Fwd: Starbucks 1360 Walton Blvd - Restrict Left Out at Walton Blvd Option - CF#21-030 / RCOC PRELIMINARY PRELIMINARY PLAN REVIEW 21P0036

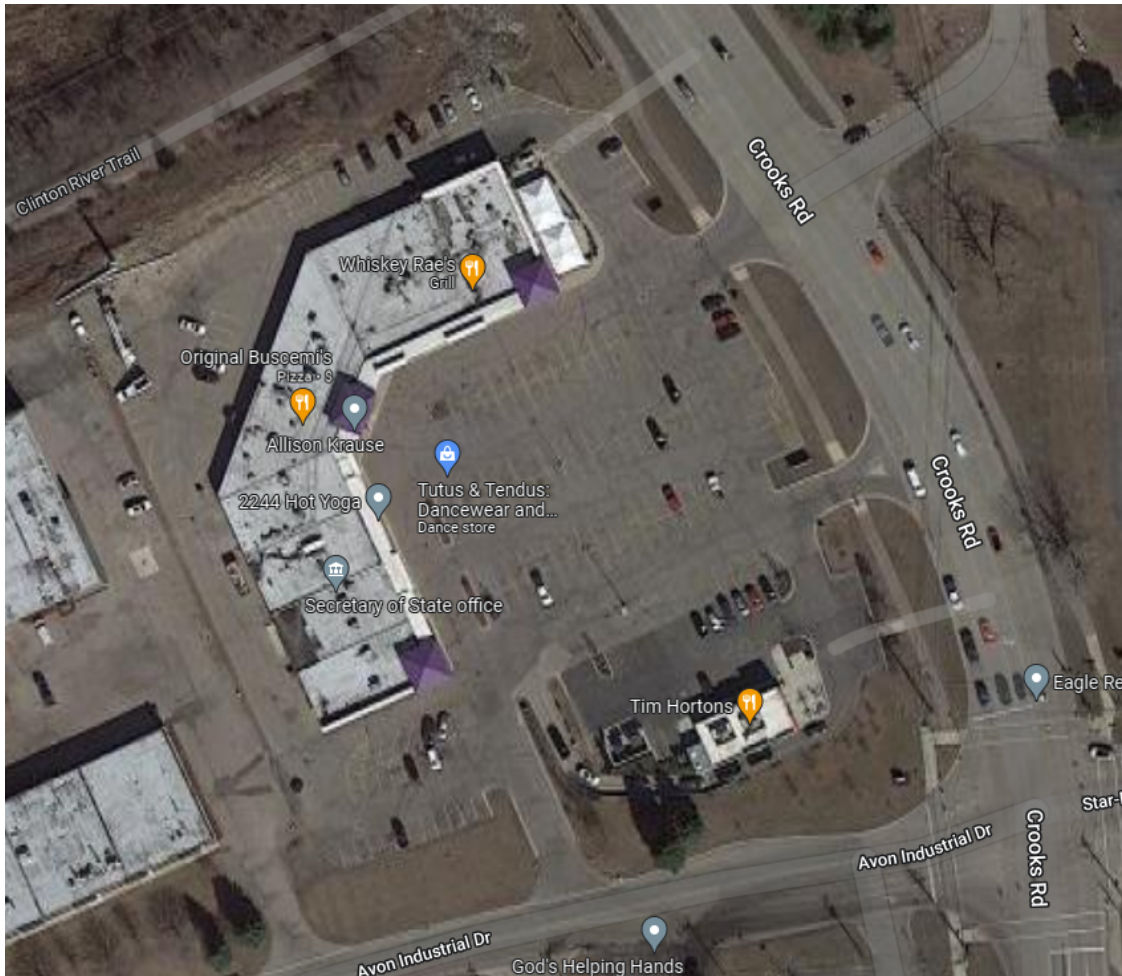
2. Allow full access drive (assuming option 1 is not feasible)

- Not ideal due to the high AM peak use that will be competing with AM school traffic at Rochester High School.
- School and drive thru traffic will be competing for limited CLTL storage length and weaving in and out of the lane to get around staged vehicles.
